DESCRIPTIVE REPORT

Type of Survey ... Hydrographic
Field No. RA-10-14-98
Registry No. H-10837

State Alaska
General Locality Southwest Prince William Sound
Sublocality Eleanor Island to North Part of...
..... Knight Island

Descriptive Report to Accompany Hydrographic Survey H-10837

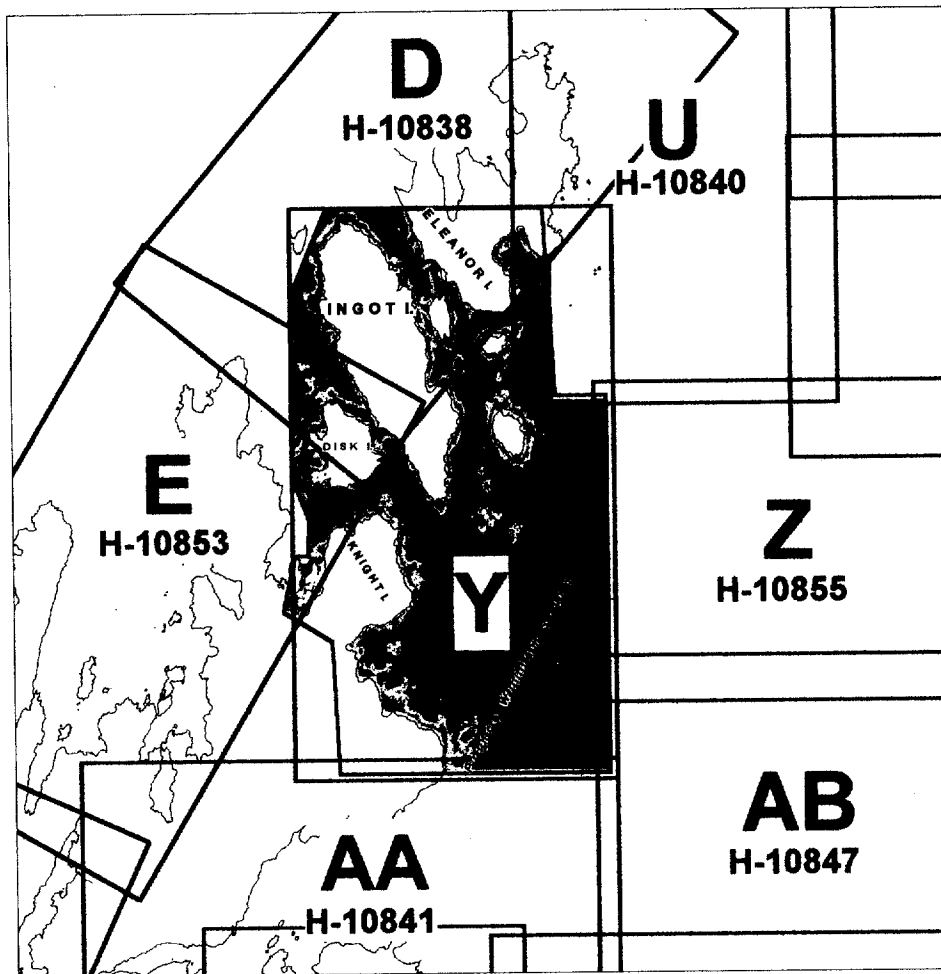
Soundings on these 1998 surveys were found to be in good agreement, generally matching within 1 fathom. *Concur*
 Minor exceptions occur in deep water, where the single beam data differs with the Rainier's multibeam soundings from H-10855. These differences can be explained by the difference of beam width, power output, and angle of incidence between the two systems. The deeper multibeam soundings are more accurate, thus the hydrographer recommends using data from H-10855* in areas where H-10837 overlaps with H-10855. Final comparisons will be made at the Pacific Hydrographic Branch (PHB) after reduction to final vertical datum. *The junction soundings with H-10855 agree very well (0.2 Fms) in depths that range from 70-100 fathoms. Selection of depths are acceptable from either survey.*
do not
** Concur*

Item Investigation #1

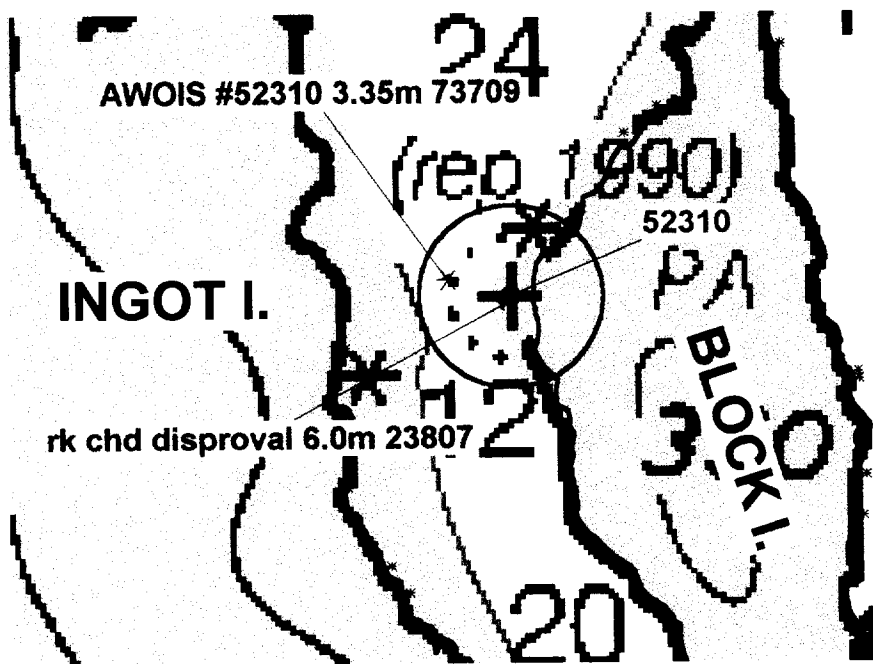
AWOIS item number 52310 was located approximately 110 meters to the north-west of the described AWOIS location. The hydrographer recommends removing the charted rock at 60° 31' 27".00 N 147° 36' 56".00 W, and chart a dangerous submerged rock of known depth at 60° 31' 27".81 N 147° 37' 02".67 W, as determined with MOD III least depth gauge (SN# 68333) at 3.35m. Concur Chart 08 Rk 1.6m*

Item Investigation #2 ✓

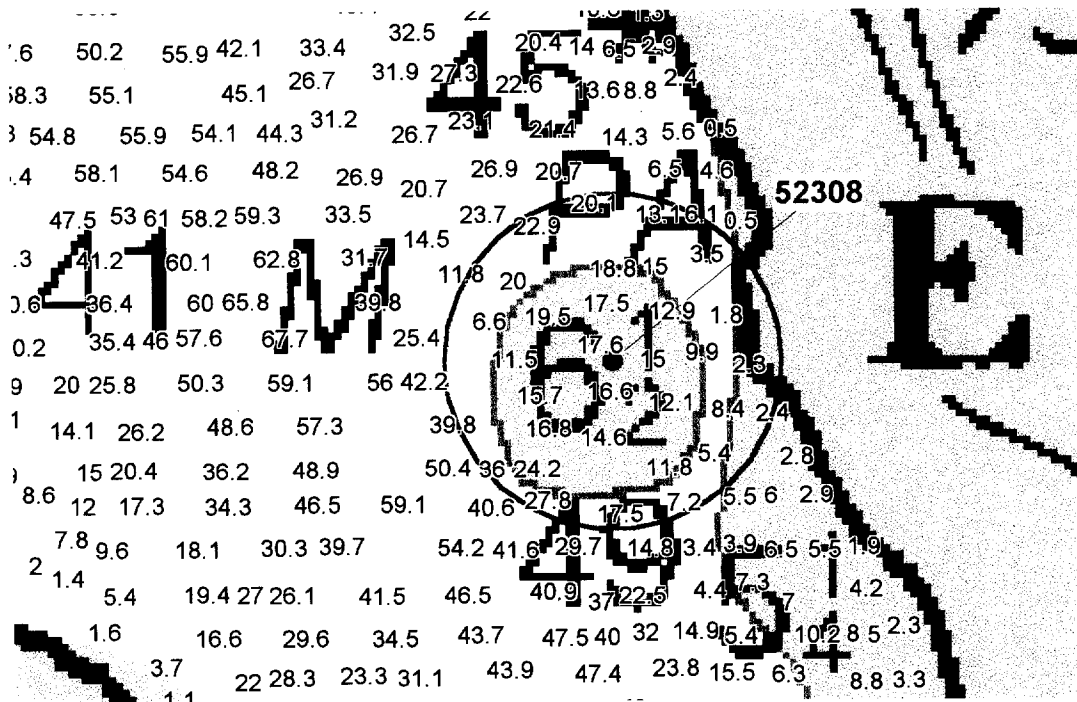
AWOIS item number 52308 was located approximately 150 meters to the north-west of the described AWOIS location. The hydrographer recommends that the 6.5 fathom shoal be moved offshore to reflect the current surveyed position. Concur with clarification. Remove charted 6 1/2 Fm sounding. Chart 6 1/4 Fm sounding from present survey.

Item Investigation #3 ✓

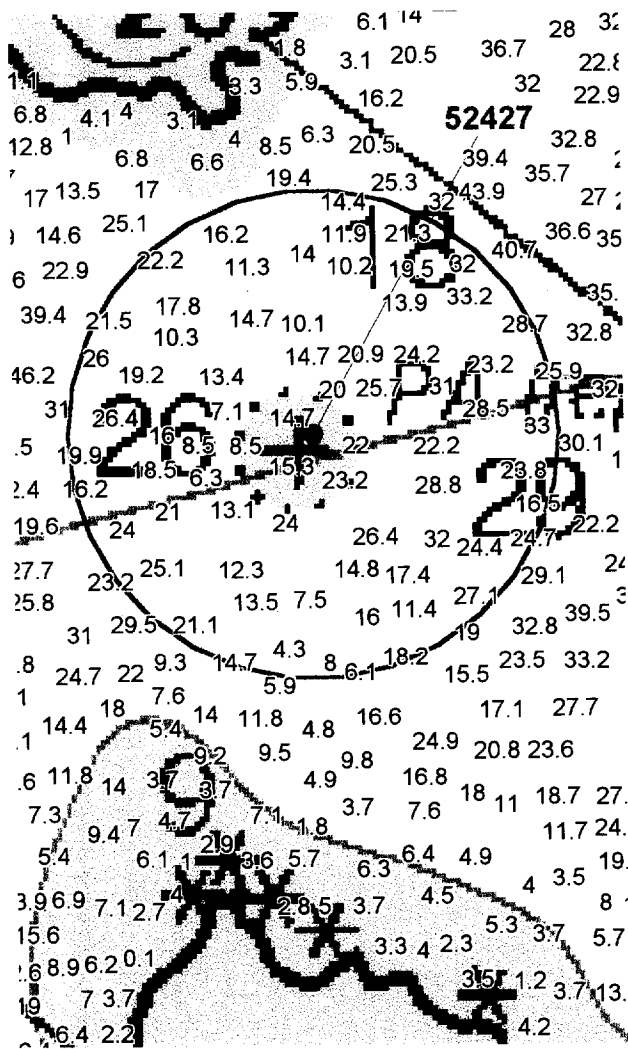
AWOIS item number 52427 was located approximately 190 meters to the south-west of the described AWOIS location. The hydrographer recommends removing the charted dangerous underwater rock of uncertain depth at 60° 30' 33".74 N 147° 34' 55".10 W, and chart the current depths to reflect this survey, with the shoalest point at 60° 30' 31".54 N 147° 35' 06".52 W of 6.3 Fathoms. Concur

Chart 6.2 Fm Sounding.

Item Investigation #4 ✓

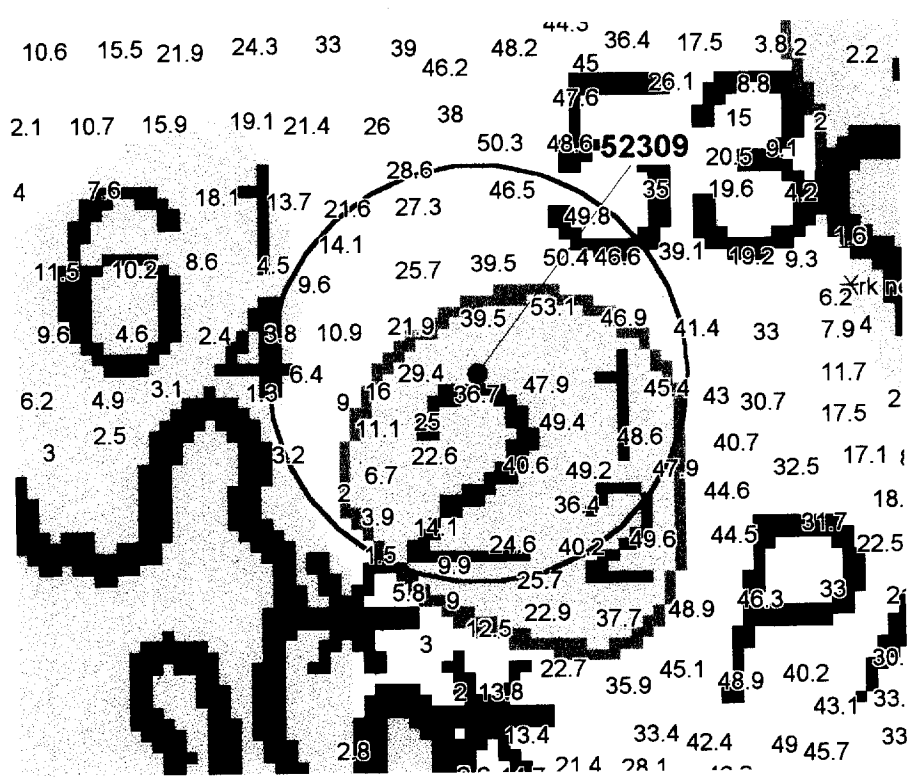
GEOGRAPHIC POSITION	POSITION #
CHARTED:	60:32:00.77 N, 147:37:25.15 W	
OBSERVED:	60:31:58.04 N, 147:37:31.49 W	Fix# 40056
POSITIONED BY:	DGPS	DATUM: MLLW
METHOD OF INVESTIGATION: 100% SWMB coverage, mainscheme/50m split SB coverage		
FINDINGS: Shoal sounding disproved by hydrography <i>Concur</i>

A 2 Fathom shoal sounding is ^{charted} located 60 meters east of the shore of Ingot I., and is not unusual for near shore bathymetry. The hydrographer recommends removing the 2.5 fathom shoal, and chart the current depths to reflect this survey. *Concur*
